IMPORTANT RECALL NOTICE

2001 model year F4000 SL
2001 model year Jekyll 4000 SL
2001 model year Raven 4000 SL
2001 model year Lefty Carbon ELO aftermarket fork

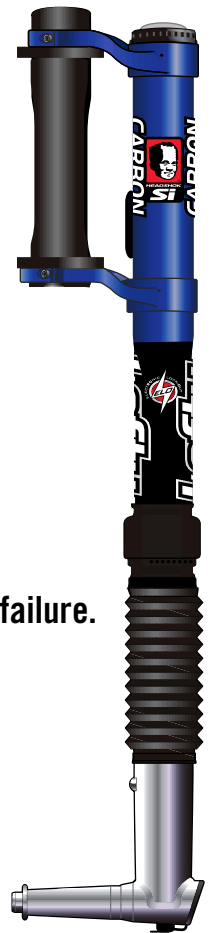
There are two problems: (1) The needle bearings could escape past the lower collar. This failure could result in loss of steering control. (2) The epoxy adhesive bond between the carbon inner tube and the titanium spindle may loosen or fail. This adhesive failure will weaken the fork and might lead to fork failure.

Cannondale will promptly rebuild these forks at our HeadShok Factory Tech Room. Our experts will: rebuild the lower assembly, rebuild and lubricate the needle bearing assembly as needed, install a new lower collar and a new boot. We will also install a new 2002 cartridge featuring improved negative springs and capability for 80 or 100mm of travel. Once this work is done, you will have a "2002 fork" that performs better than new.
